Objection to SSD-82599709 at 153-157 Walker Street, North Sydney

This objection has been prepared in response to the proposed development at 153–157 Walker Street, North Sydney (SSD-82599709). The following matters are raised as key planning concerns and grounds for objection, based on identified non-compliances and inconsistencies with the North Sydney Local Environmental Plan 2013 (NSLEP 2013), the Apartment Design Guide (ADG), and amenity impacts of the proposed development.

Figure 1 Solar access elevations as identified within the EIS. Indicative outline of 146 Arthur Street in red, not shown within solar analysis

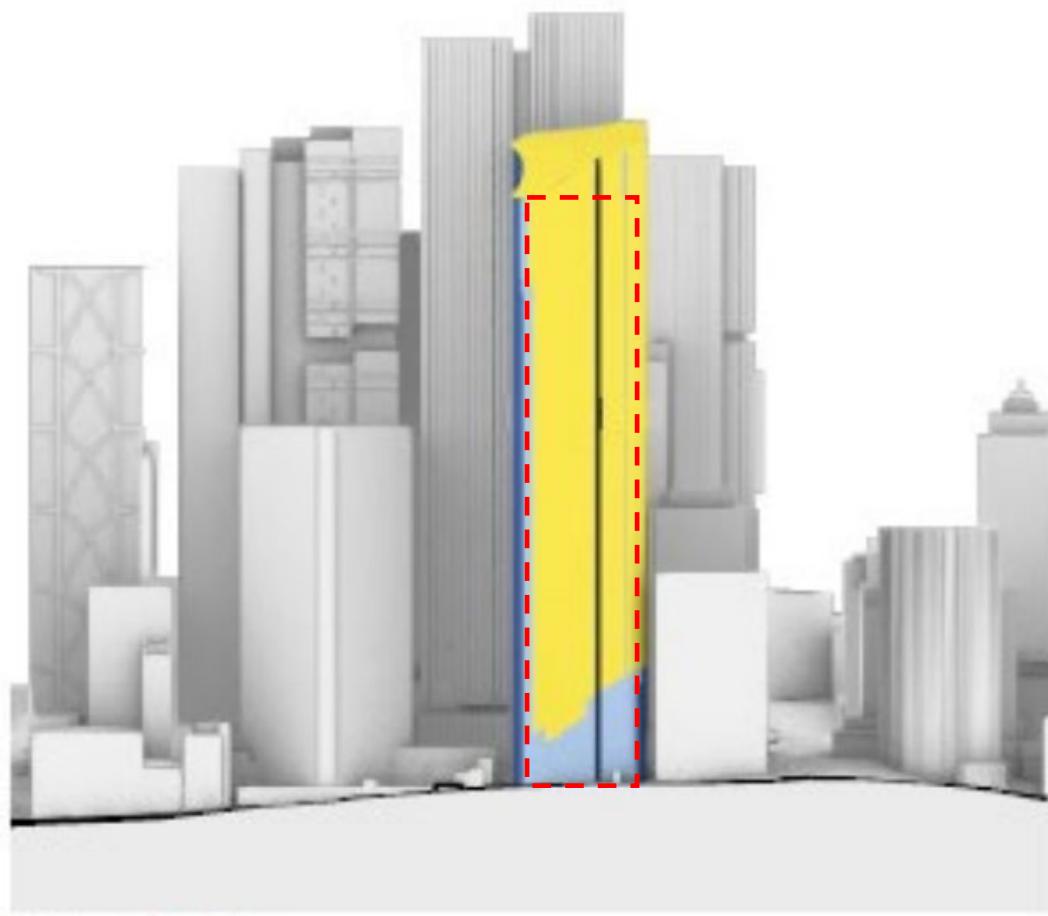
The solar access analysis presented within the EIS is incomplete, as demonstrated within Figure 1 below, it does not include the approved development at 146 Arthur Street within its modelling. Given the close proximity and height of that approved tower, its inclusion is likely to have a material impact on the extent of sunlight available to the proposed development. As a result, the reported levels of solar compliance may be overstated and do not accurately reflect the true conditions that will exist once both developments are realised. The omission undermines the reliability of the EIS conclusions

regarding solar access and amenity, and further assessment is required to demonstrate genuine compliance with the Apartment Design Guide and SEPP 65 objectives.
